14541
22 July 2016

**AMENDED DRAWINGS
STAGE 13 DISCOVERY POINT, 1 PRINCES HIGHWAY (DA-2016/99)**

Figure 1 – Comparison of amended Building 13 floor plate (Level 11-15)

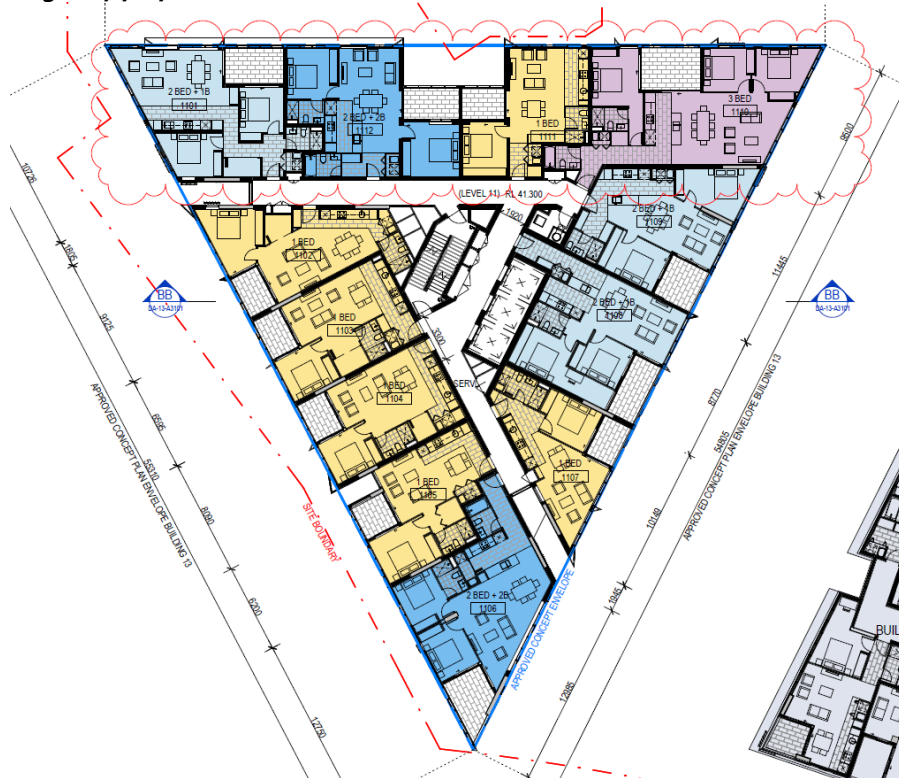
The western façade line of Building 13 has been amended to provide a greater setback and altered interface with the airspace above the existing railway substation. As a result of this façade line change, the internal arrangement and distribution of apartments within Building 13 has been amended, resulting in a reduction of nine (9) apartments.

The changes to the apartment layouts are illustrated in the Architectural Drawings prepared by Group GSA (**Attachment A**). **Figure 1** below provides a comparison of a typical floor level in Building 13, illustrating the amended design compared to the original design. The amended drawings also provide four x one bedroom & one x two bedroom adaptable apartments to address condition 47 of the draft development consent.
